GULF STATES UTILITIES COMPANY

July 15, 1985
RBG-21,546
File No. G9.5, G9.8.6.2

River Bend Station - Unit 1
Docket No. 50-458

Enclosed for your review is additional information to clarify Gulf States Utilities Company's (GSU) position regarding a Request for Additional Information (dated November 14, 1983) identified by the Nuclear Regulatory Commission, Structural and Geotechnical Engineering Branch (SGEB). This letter supplements information contained in a letter from Booker to Denton dated October 8, 1984 (RBG-19,194) and provides a basis for not performing additional analysis relating to the subject of in-plant SRV testing.

CLEVELAND ELECTRIC ILLUM. - PERRY NUCLEAR POWER PLANT
FLOOR RESPONSE SPECTRA
NODE 219 VS ACCELEROMETER 46
RADIAL DIRECTION - 2% DAMPING

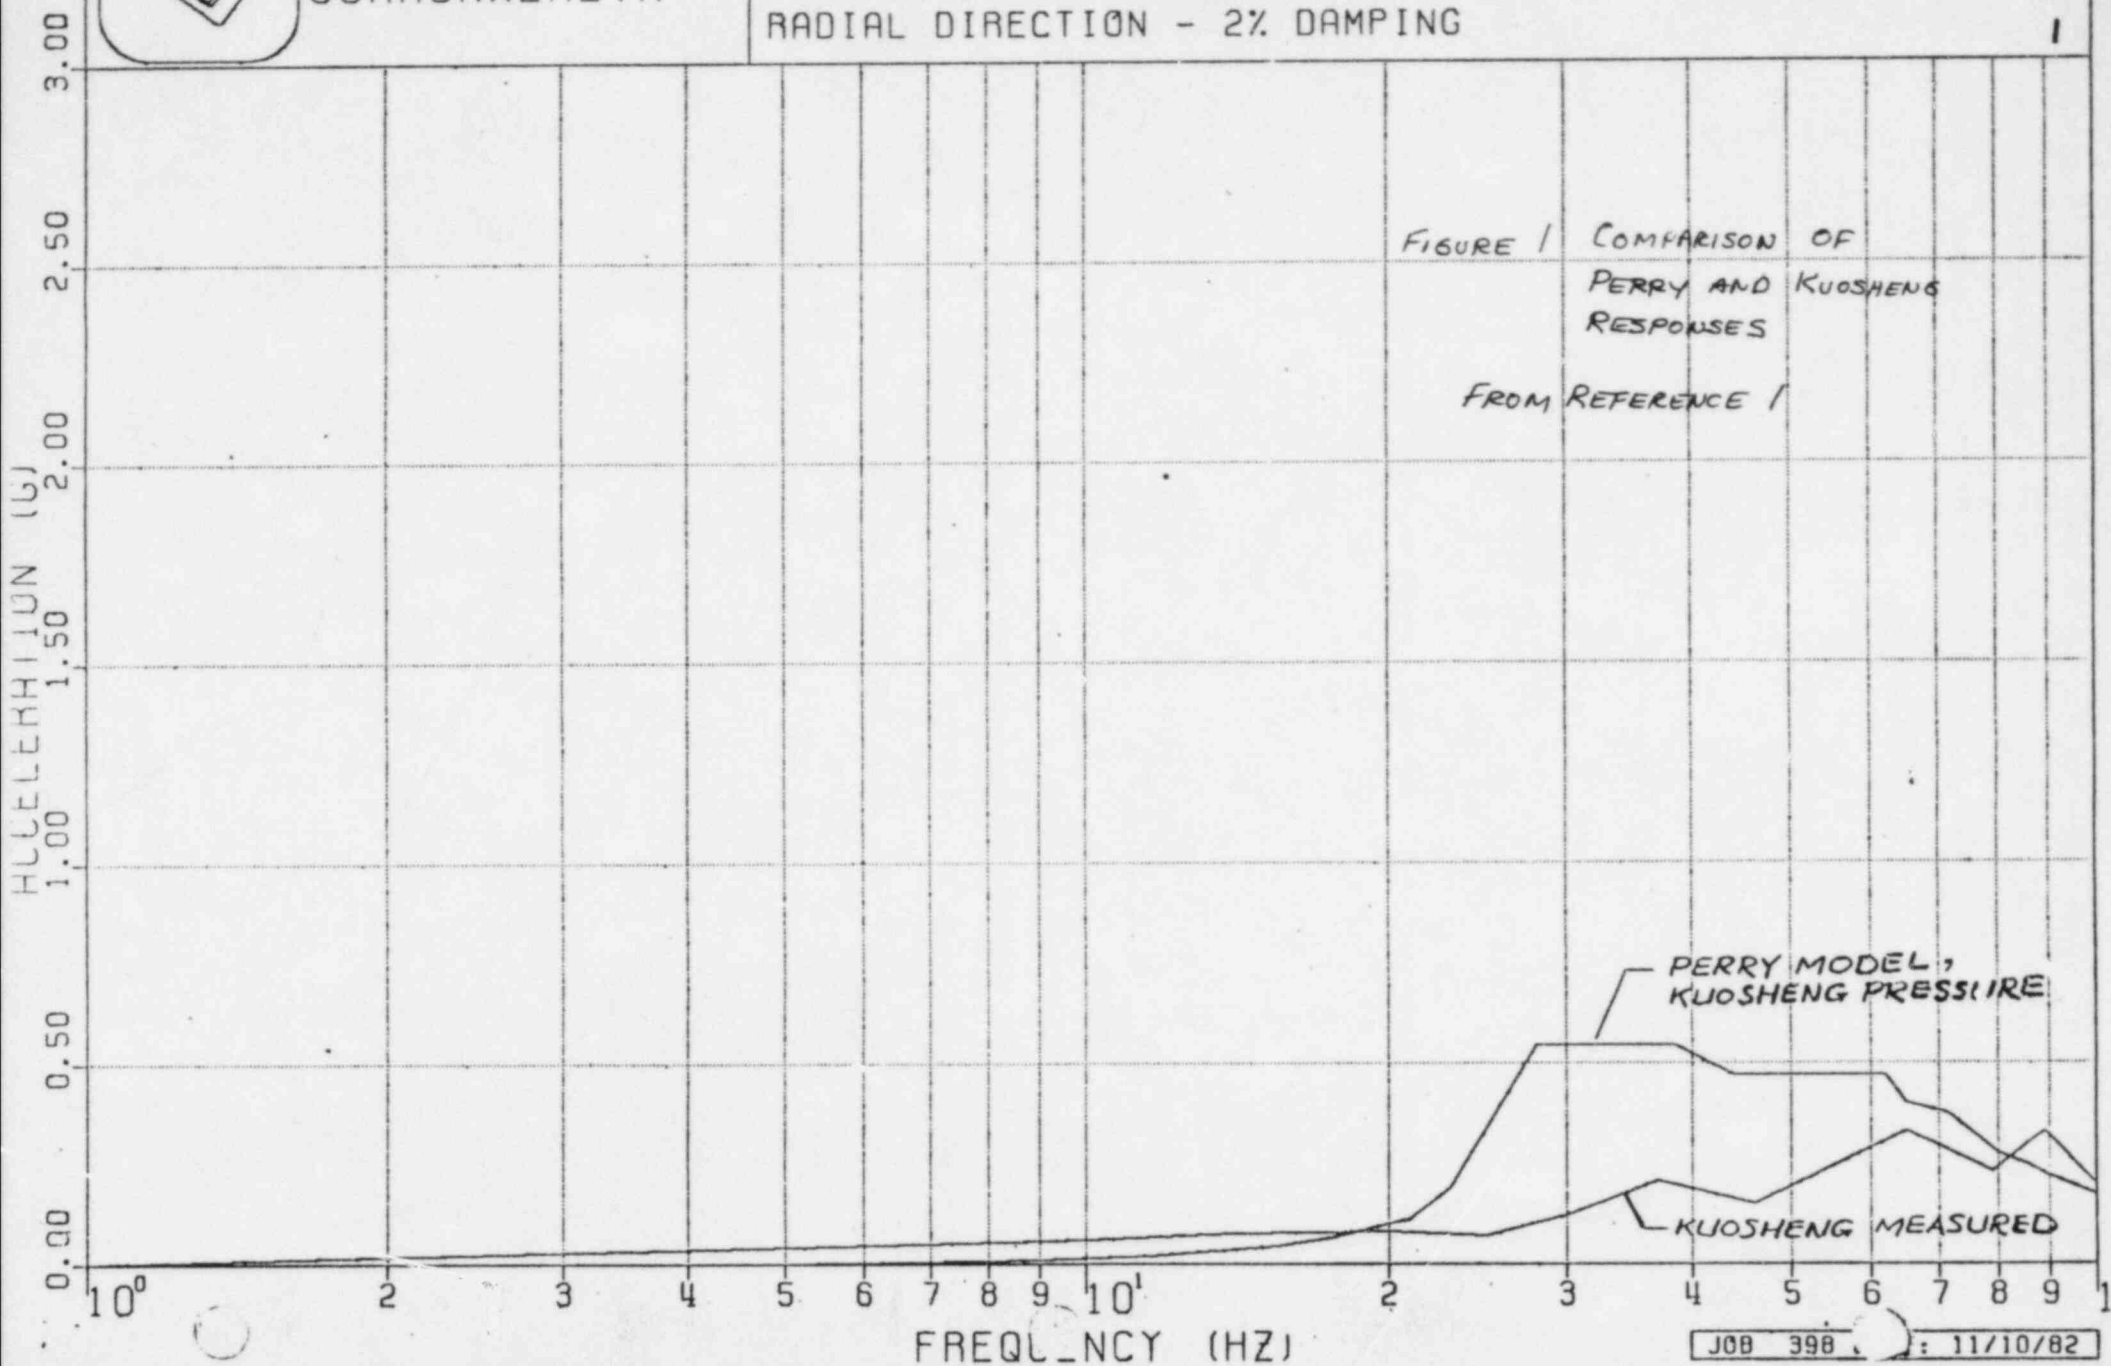
In conversations with the Structural and Geotechnical Engineering Branch, a concern was identified that the differences between the soil shear wave velocities at Perry (4900 fps) and River Bend (960 fps) would cause differences in the response of the structures due to soil-structure interaction. For these reasons River Bend should perform an analysis like the analysis performed by Perry.

- 1) Examination of Figures 1-3 show negligible responses below 20 Hz. This indicates that the Kuosheng observed pressure trace does not excite lower modes of vibration of the Perry analytical model, nor of the actual Kuosheng structure.

- 4) At higher frequencies, where soil-structure interaction effects are not significant, the River Bend responses to the Kuosheng pressure trace would be similar to those calculated for Perry, since the containment structures are similar. These responses have been found to be acceptable based on the comparison with the Kuosheng measured responses as shown in Figures 1-3.

Figure 2-14
DESIGN RESPONSE SPECTRA COMPARISON - SRV + SRVCO
CONTAINMENT ELEVATION 80'-0" - RADIAL

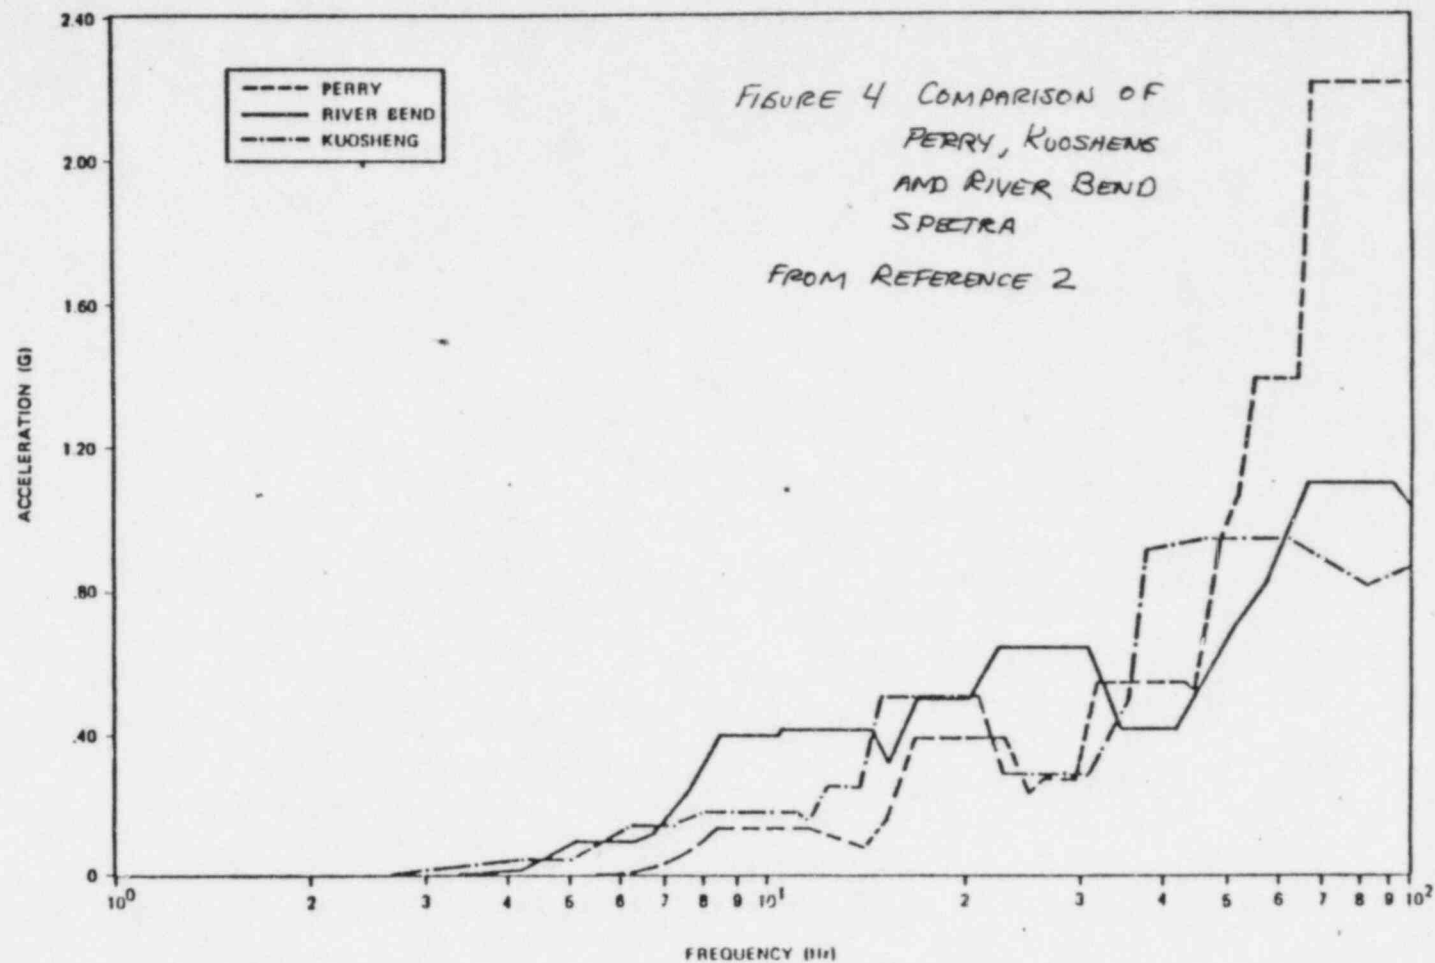
- 3) The River Bend design response spectra (Figure 4), which is extracted from Reference 2, does have significant response in the lower frequencies. This indicates that the River Bend design SRV load, described in GESSAR, has more energy in the lower frequency range and is therefore more conservative in this area than the Kuosheng traces.

Therefore, It is concluded that the results of the Perry Analysis are applicable to River Bend, and it is not necessary to perform the same study for River Bend.
